Final

KEWAUNEE NUCLEAR POWER PLANT

DOCKET NO. 50-305

Comments on Draft Environmental Statement

Fig. III-6: Observed Plume Dispersion for Point Beach Unit 1 on June 25, 1971.

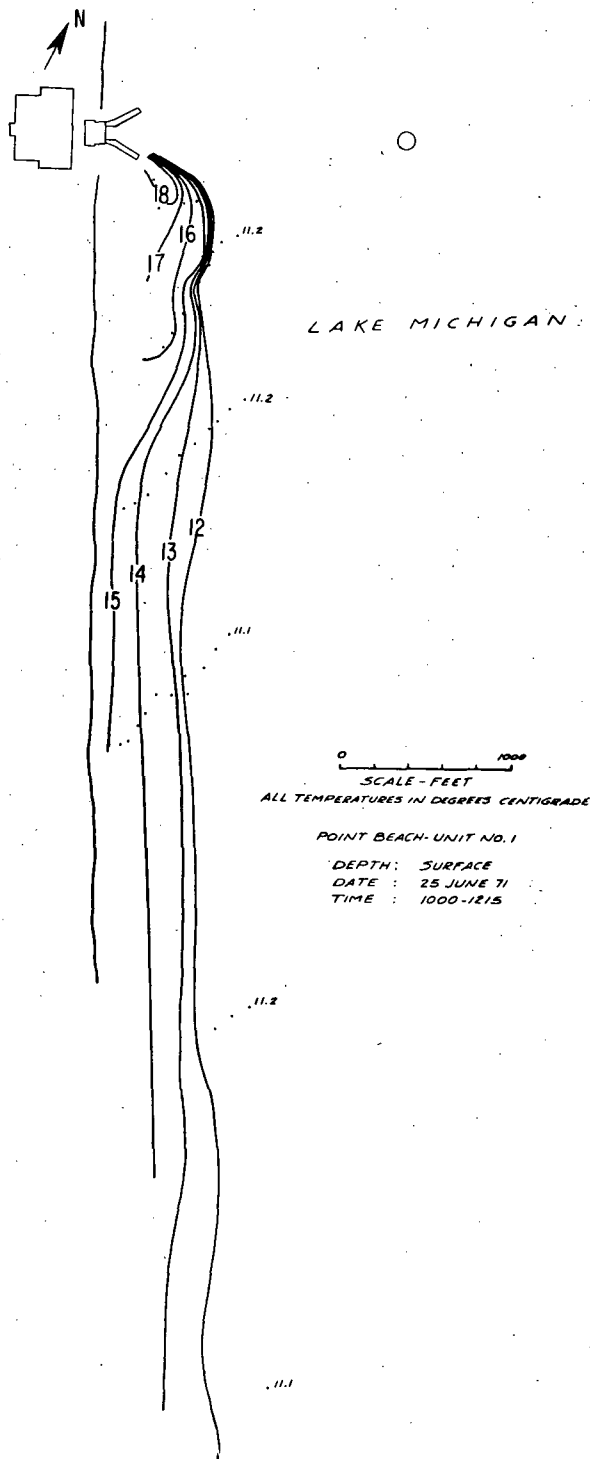
The effect of strong shore-parallel currents would be to cause the plume of warm water to flow near the shore, as shown in Figure III.6 (for the Point Beach Plant). However, the conditions that promote these strong near-shore currents, i.e., strong winds from the north, northeast, and southeast, also create rough lake conditions, a great deal of turbulence (as indicated by turbidity levels) and waves breaking in the vicinity of

the beach and outfall. These conditions promote mixing and partially, if not completely, compensate for the plume being bounded on one side by the shoreline. Figure III-6 illustrates that the initial temperature has been attenuated within a few hundred feet as a result of the ambient turbulence. Thus, strong shore-parallel currents are not expected to subject entrained organisms to maximum temperatures for a greater time than that estimated in Section III.D.1.b.

Fig. III-7: Observed Plume Dispersion for Point Beach Unit 1 on August 31, 1971.

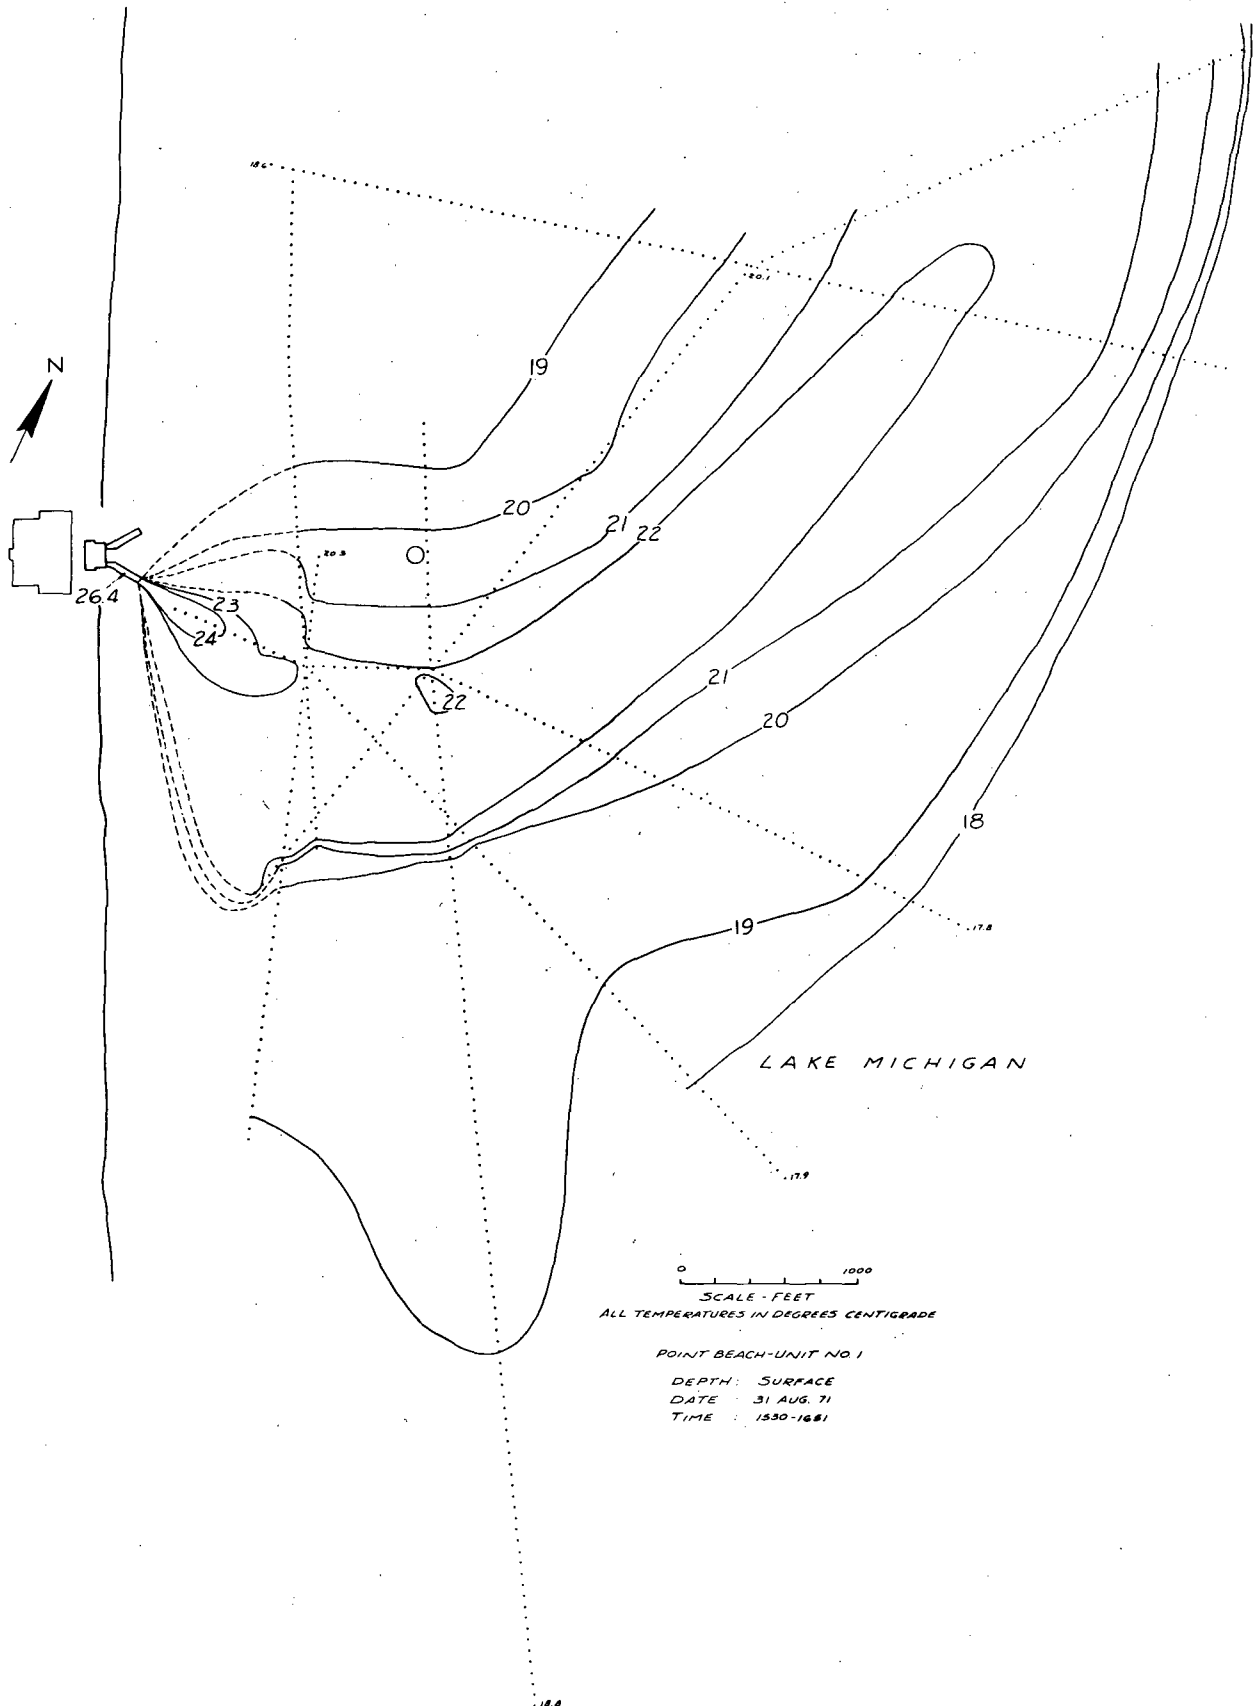
We agree with AEC in the conclusion in the second paragraph on page III-9 that the mathematical model may not present an accurate indication of plume size. However, Figure III-7, showing the Point Beach plume on August 31, 1971, would appear to indicate that the applicant's data are reasonable. The Point Beach Unit 1, August 31, 1971, plume indicated distances in excess of a mile. The area enclosed by the 3°F isotherm is a significant area even though it may be less than 1,000 acres, as estimated by the applicant, or more than 254 acres, as estimated by AEC.

It is not clear that the large Point Beach plume shown in Figure III-7 proves or disproves the Applicant's analysis, as stated in the comment. It is a large plume and was included with Figure III-6 to illustrate the variability of plumes observed in an area very near the Kewaunee site. An analysis of ambient lake current data at the Point Beach site indicated that the current shifted from a southerly to a northerly flowing current during the morning of August 31. Thus, for a period of time the plume was mixing, not with ambient lake water, but with water previously associated with the plume. The Applicant's model did not represent this situation. Figures III-8 and 9 represent the plume on the following morning and afternoon (Sept. 1) and show a considerable reduction in size.

Fig. III-11: Vertical Profiles of the Point Beach Plume of July 20, 1971
at Distances of 1000 and 2200 Feet from the Discharge.

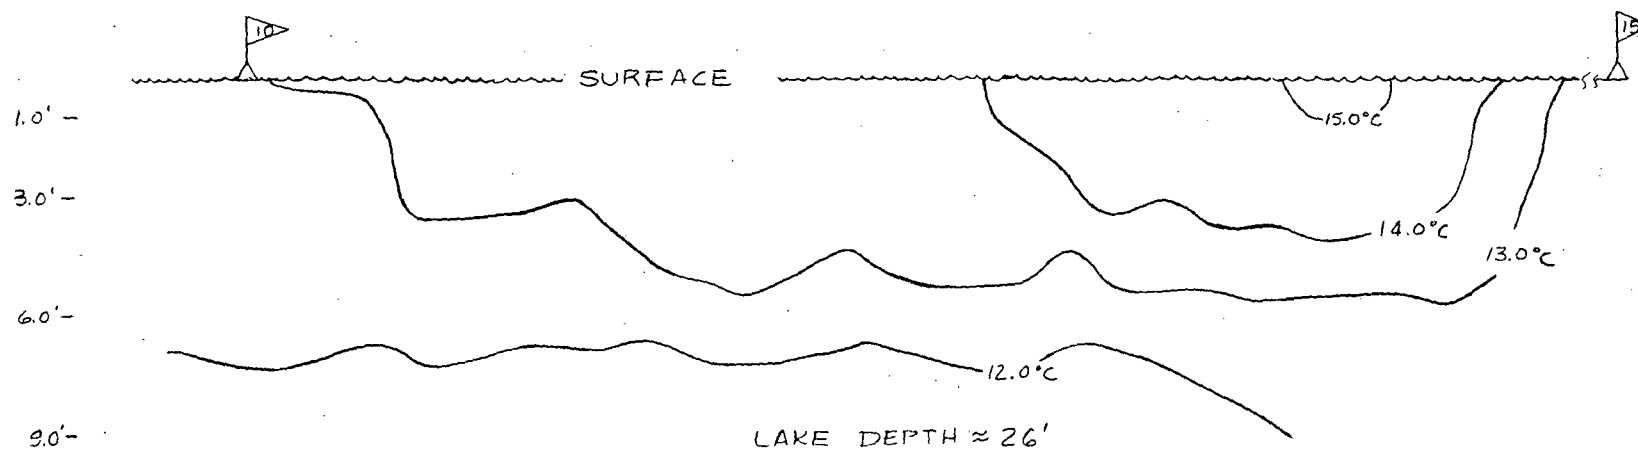
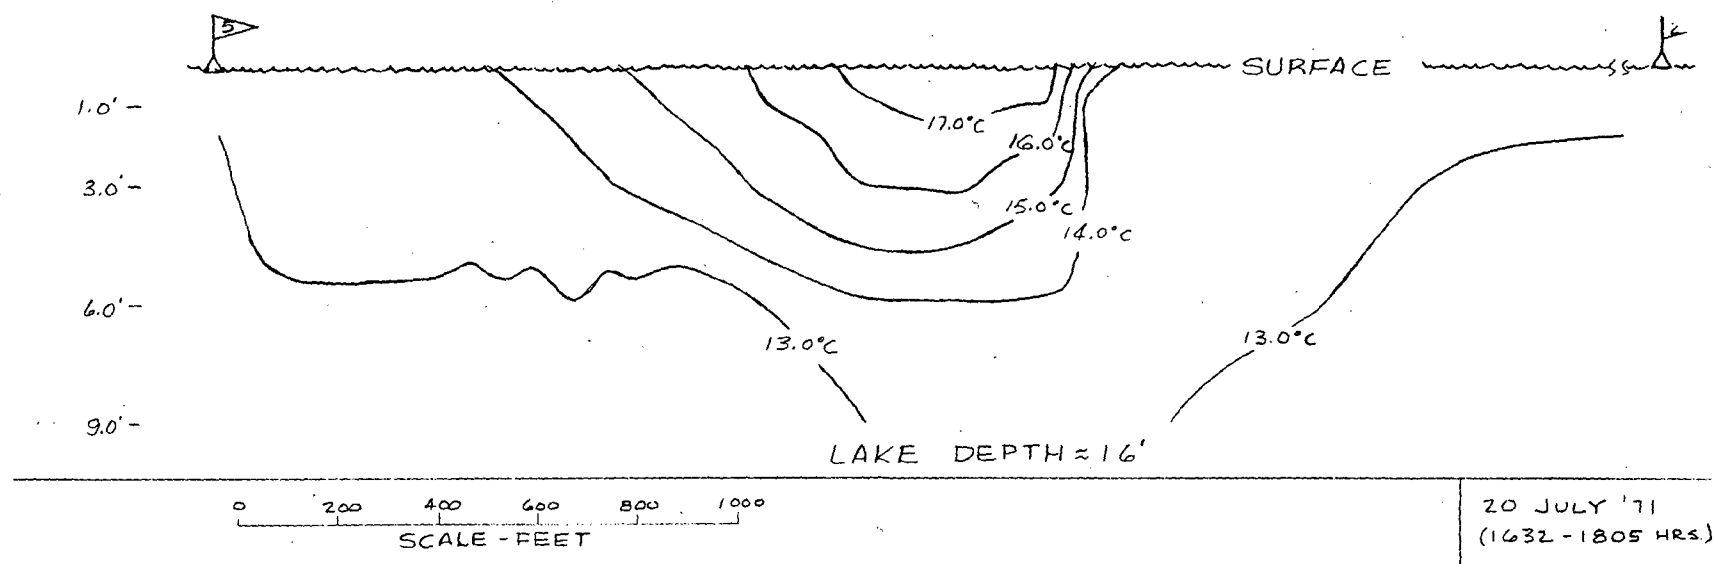
This section, beginning on page III-13, contains a good discussion of the effluent plumes. We think that the intake temperatures and the plant load factors should also be included for the comparison with the Point Beach plant. Also, Figure III-11 indicates that the Point Beach plume has not completely separated from the lake bottom at about 1,000 feet from shore where the depth is 16 feet, while it is stated on page III-13 that the plume appears to separate from the bottom within a distance of 600 feet from the discharge. If both of these data are correct, there appears to be significant recirculation at Point Beach which could indicate that there will be significant, occasional recirculation of cooling water effluent at Kewaunee where the depth at the intake located 1,600 feet from shore is only 15 feet.

Concerning applicability to the Kewaunee Plant, Figure III-11 does not indicate that the plume extends to the bottom. It shows the maximum depth of the 13°C isotherm to be about 10 feet at 1000 feet from the discharge. The lake depth was 16 feet at this point. This is not inconsistent with the statement that the plume separates from the bottom within about 600 feet from the discharge. While the "ambient" temperature is often difficult to define, the great majority of Point Beach data show that the plumes, or what can be readily identified as plumes, are about 6 to 8 feet deep near the Point Beach intake (1750 feet from shore). In the far-field, the measured depths are 6 feet or less. We have no reason to believe that it will be significantly different at the Kewaunee site.

Fig. III-14. LIQUID WASTE DISPOSAL SYSTEM
KEWAUNEE NUCLEAR POWER PLANT

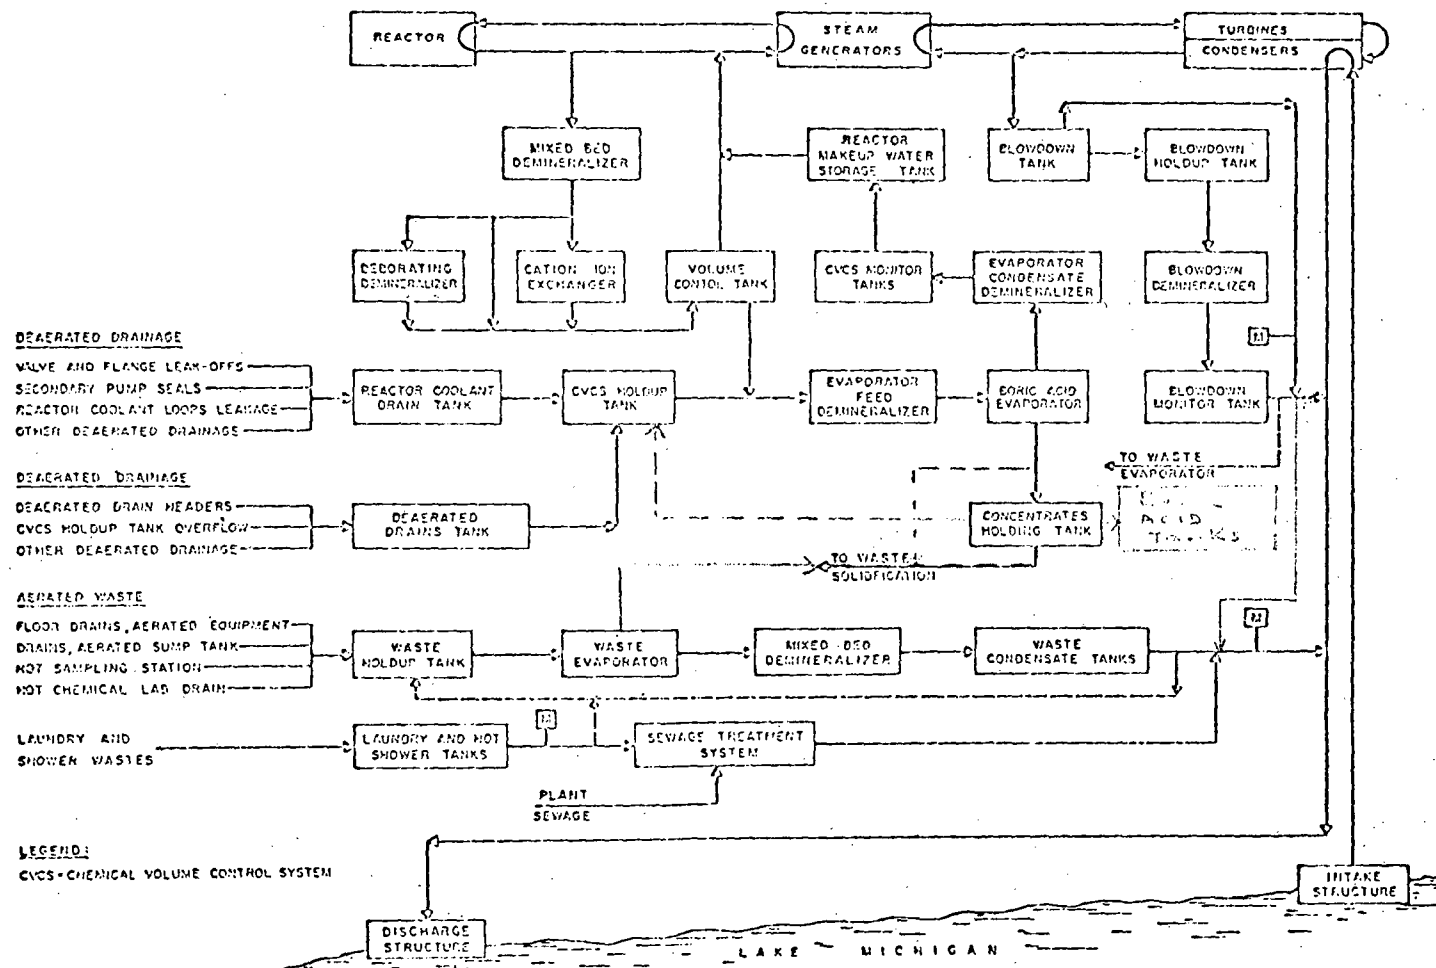
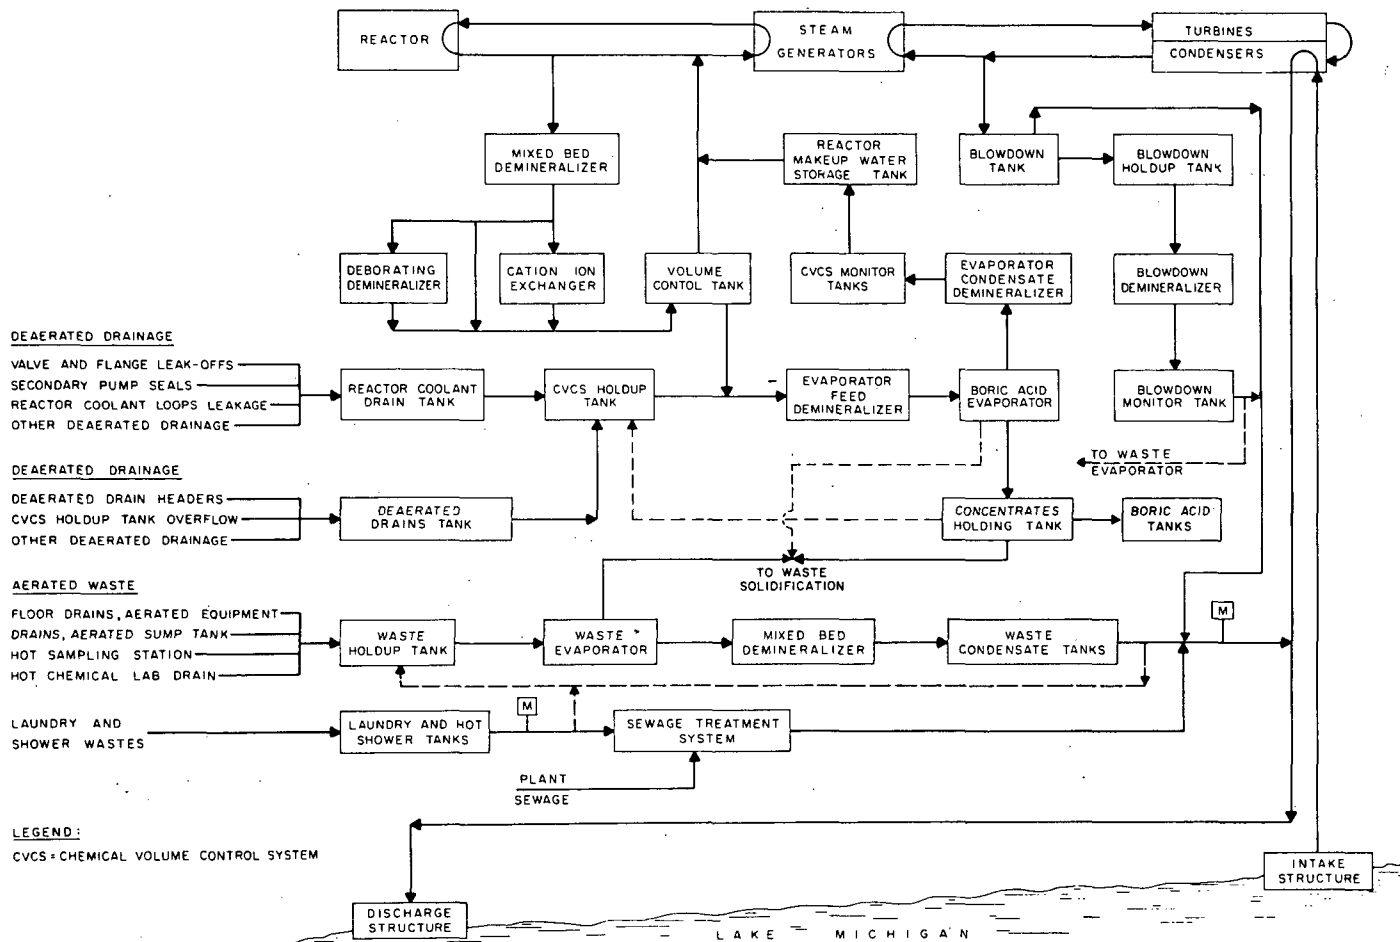
<u>Comment No.</u>	<u>Ref. Page, Figure, Table</u>	<u>Remarks</u>
1	Page II-24	Last paragraph - Analysis of surface wells mineral content have shown values of 840 ppm rather than 330 ppm.
2	Page III-23 Figure III-13	WPS has agreed to modify the steam generator blowdown treatment vent to vent to the condenser instead of venting to atmosphere.
3	Figure III-14	See attached Figure III-14 indicating flow paths.
4	Page III-26	Top of page - Last sentence change to: "Alternatively, the bottoms can be sent directly to waste solidification for processing."
5	Page III-30	Item 2, secondary coolant, boiler blowdown of coolant containing chemicals are discharged directly to the lake by way of the circulating water and are not routed to the neutralizing tank.
6	Page III-30	WPS has modified the make-up water system. (See attached - Service Water Pretreatment System.)
7	Figure III-15	See attached Figure III-15 indicating changes.
